Access Compliance Report Public Rights-of-Way (RR Crossings)

| Intersection ID: 10025543 | Main Street: E_TRADE_ST | Location: N/A |
| ADA ID: 44C3C6EB6EB0 | Overall Compliance: No | Severity Score: 0.0 |

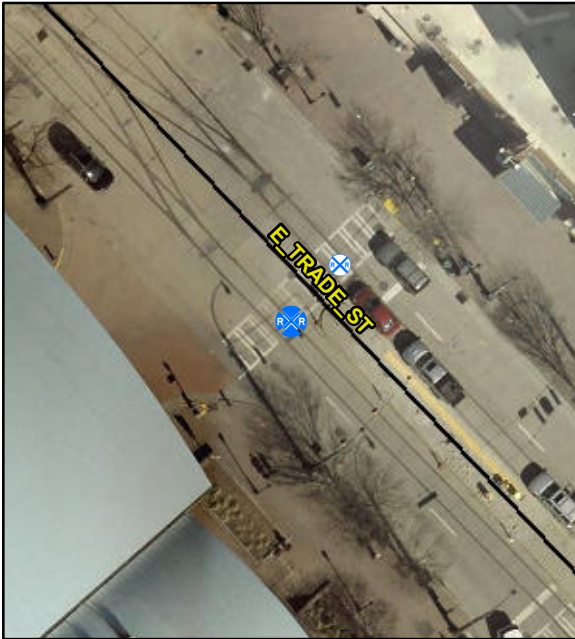
RR IN MIDDLE OF STREET

| Compliance | Description | Data |
|------------|---------------------|-----------|
| No | DWS Provided? | No |
| No | Pedestrian Gate? | No |

**Install Detectable Warning System.
Provide Pedestrian Gate.**
